FOURMILE HILL GEOTHERMAL DEVELOPMENT PROJECT

Environmental Impact Statement
Environmental Impact Report

**Volume IV: Final EIS/EIR
Comments on the
Draft EIS/EIR**

September 1998

USGS TOPOGRAPHICAL MAP
MEDICINE LAKE AREA
SCALE: 1" = 2,000 FEET EXHIBIT "A"

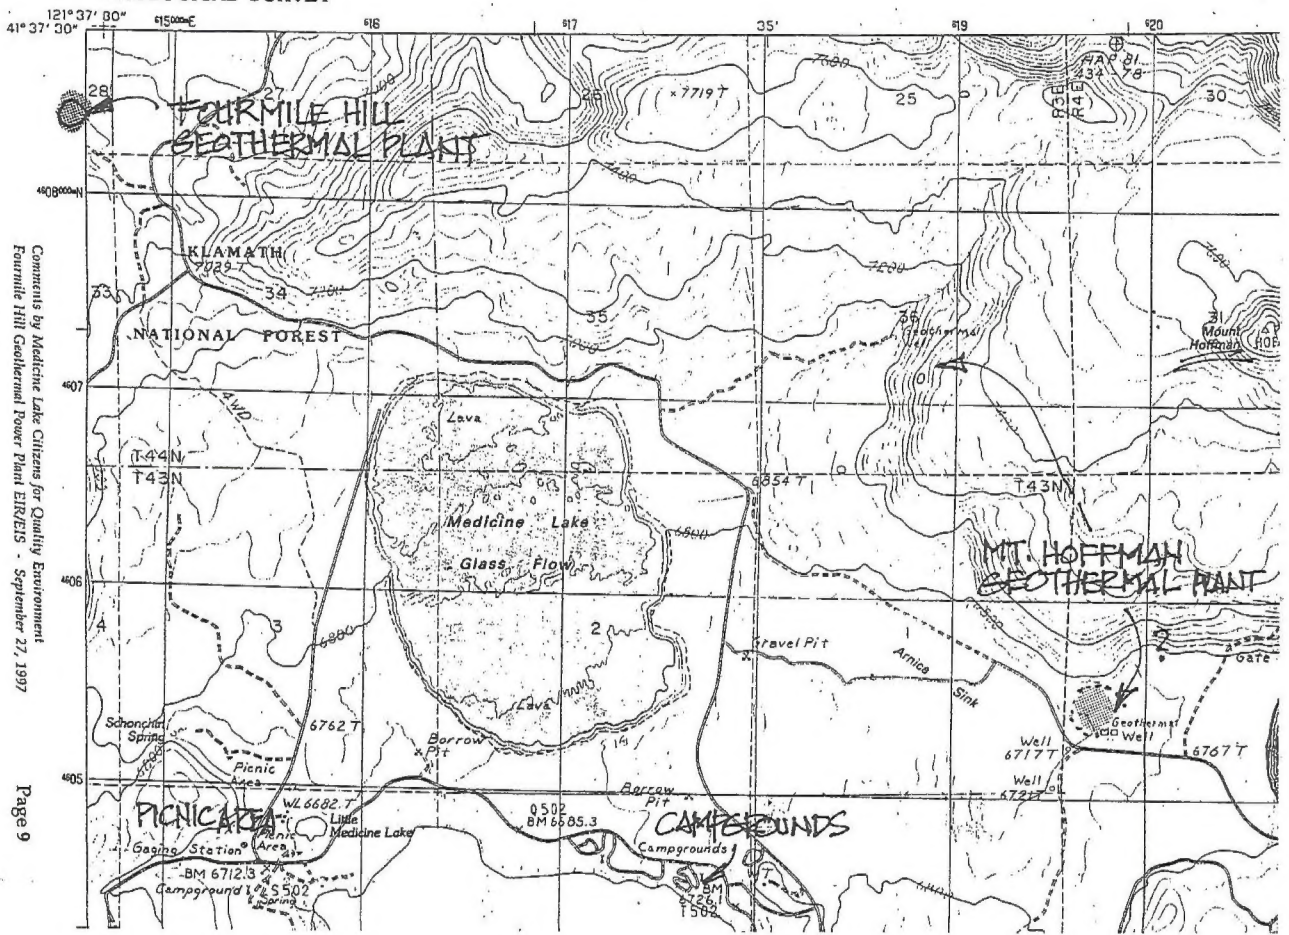
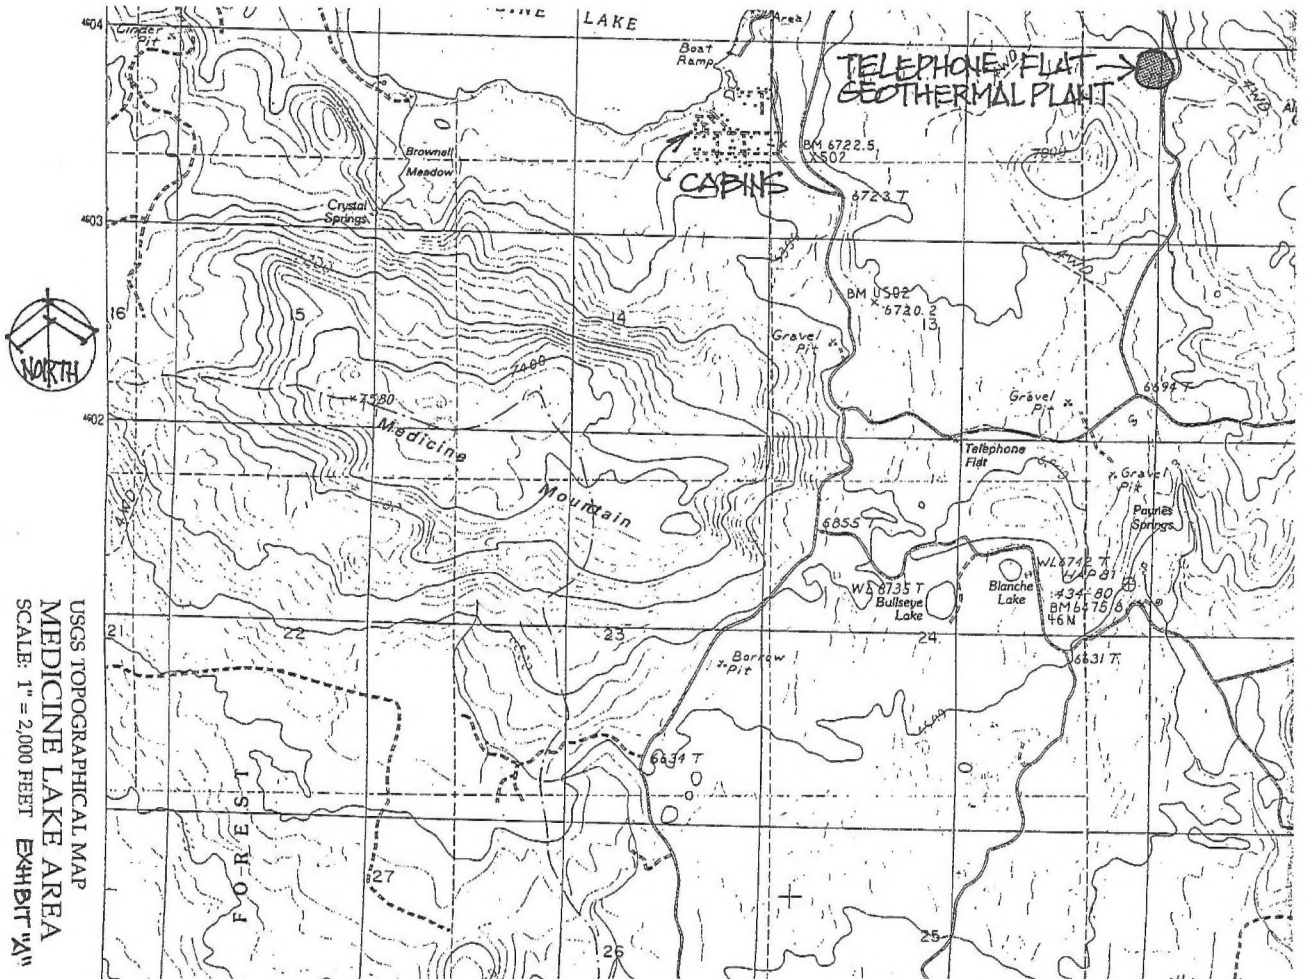
The EIR states that Telephone Flat Geothermal Plant will be about 1.5 miles southeast of Medicine Lake. Inconsistently however, the EIR map (Figure 4.17-1) shows that Telephone Flat Geothermal Plant and wellfield to be only about 6,000 feet or 1.1 miles to the east from the nearest cabins on the east side of Medicine Lake. This error in the EIR should be corrected. Moreover, behind the Telephone Flat Geothermal Plant is a prominent mountain slope which would tend to amplify facility noise by reflecting it westwards towards Medicine Lake. Those errors in the EIR tend to falsely minimize the impacts of this cumulatively foreseeable geothermal plant project.
